FRIENDS OF THE NORTH FORK NOVEMBER 3, 2011
REBUTTAL EVIDENCE LIST

Note: All documents are from DWR Division of Safety of Dams, Sacramento, files for Wastewater Storage Dam No. 2022-0

Wastewater Storage Dam, No. 2022
Placer County

WASTEWATER STORAGE DAM, NO. 2022
TAPatton 9/29/78

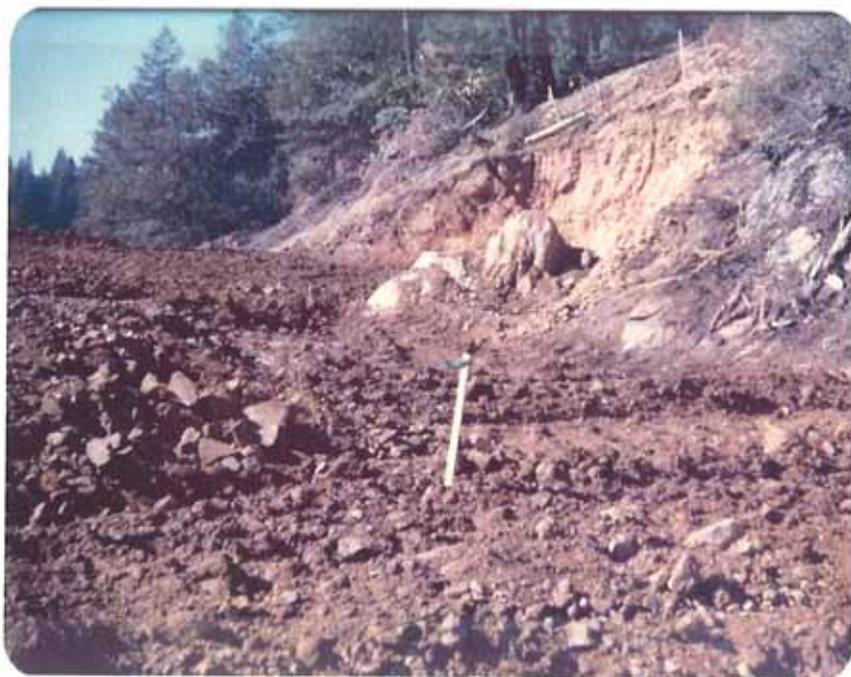
Closeup of right abutment. Two large boulders in background are the ones referred to in the report. Left of the lath you can see the end of the two foot lift.
